5TH ST S.E. CUP
111 5TH AVE NW
PUYALLUP, WA 98372

ELEVATIONS

A 3.0

Please complete and submit a nonresidential design review application and the required design review narrative as a part of your re-submittal. A review of the permit application for conformance with PMC 20.26.300 Non-Residential Design Review has been provided below. Please reference these notes when updating your plans.

ELEVATIONS

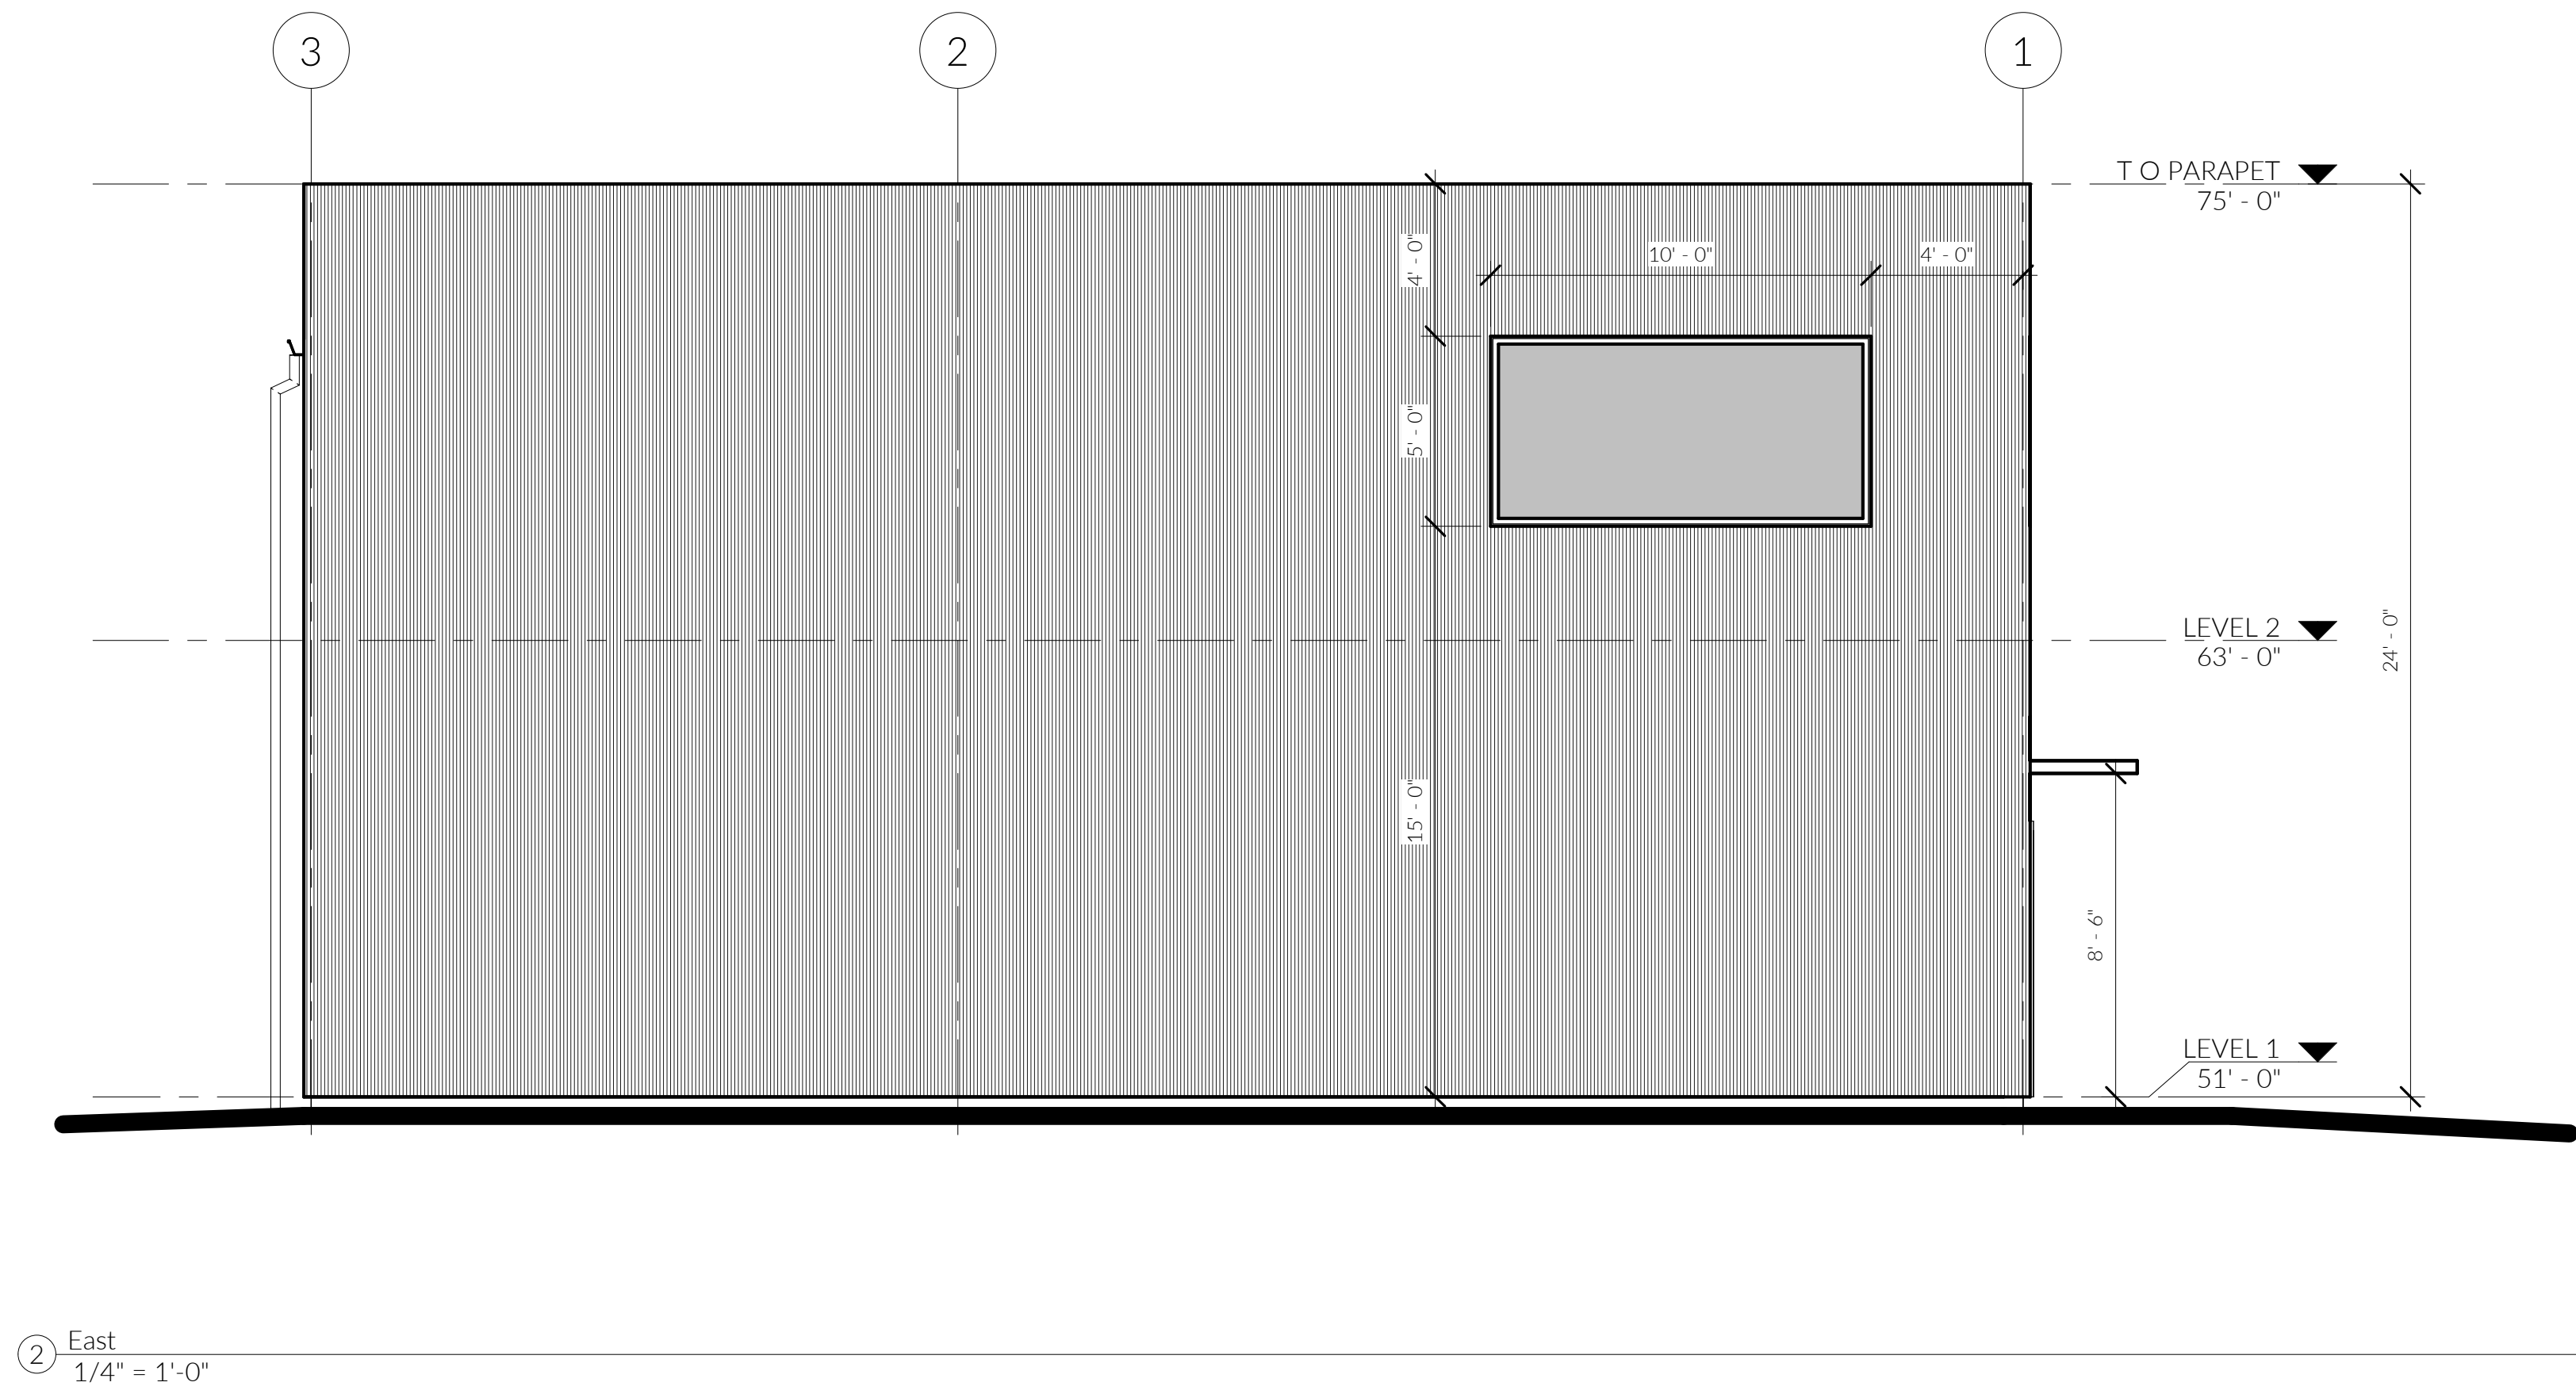
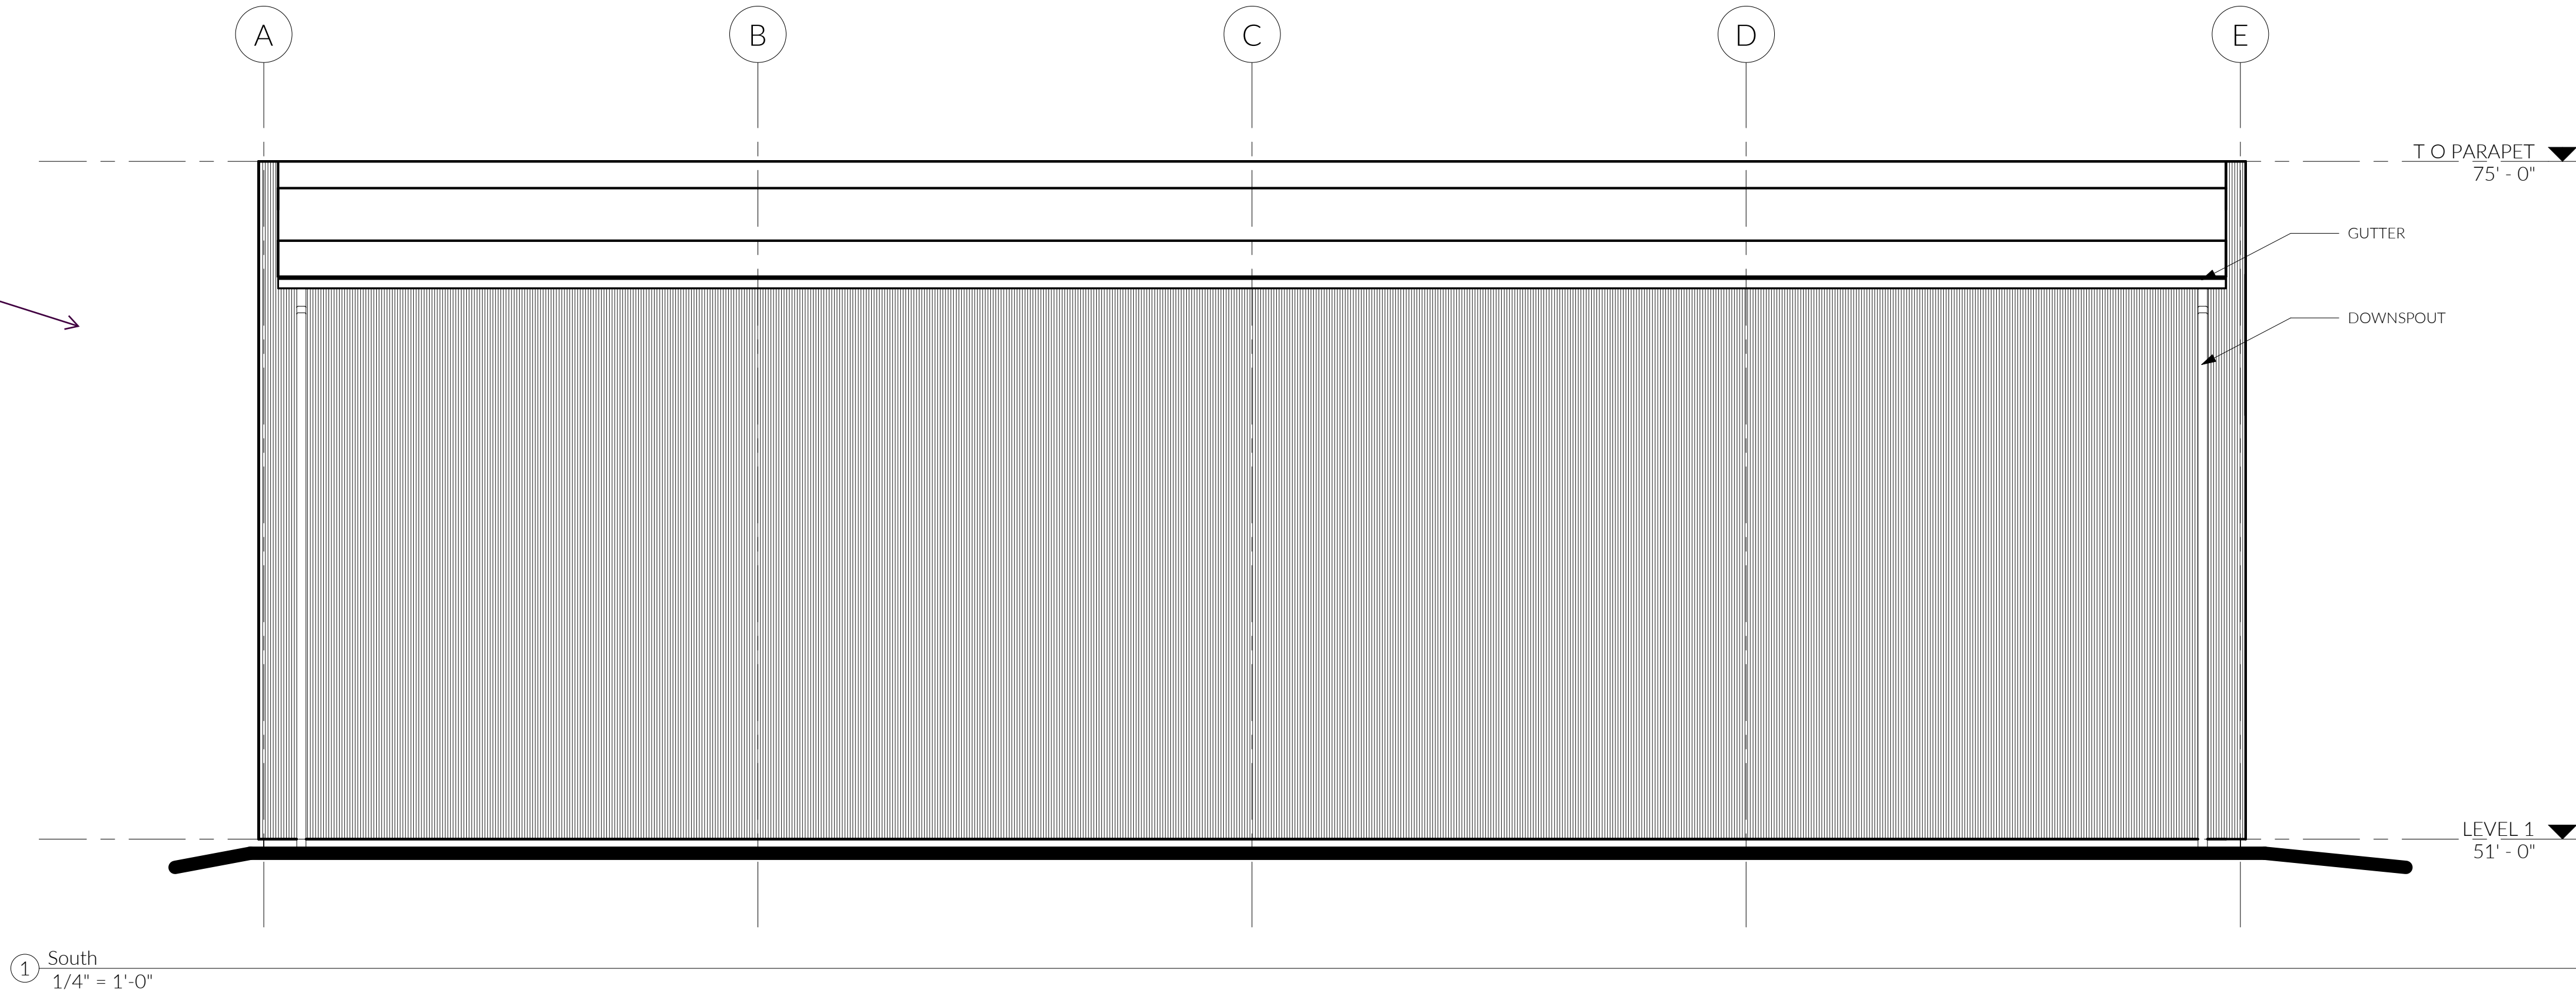
The south elevation of the building is visible from a public street and contains 400 square feet of surface area without windows, doors, building wall modulation, or other architectural features. Two screen or treat the wall, please choose two of the following methods or techniques to address this blank wall per PMC 20.26.300 (2)(a):

- (i) Installation of a vertical trellis with climbing vines or plant material in front of the blank wall;
- (ii) Providing a landscaped strip at least 10 feet in width in front of the blank wall and planted with plant materials which will obscure or screen at least 50 percent of the blank wall within three years;
- (iii) Use of alternate building materials or wall textures in the exterior treatment of the blank wall; or
- (iv) Use of functional or nonfunctional architectural features such as windows, doors, pillars, columns, awnings, roofs, etc., which cover at least 25 percent of the wall surface.

[elevations, A3.1]
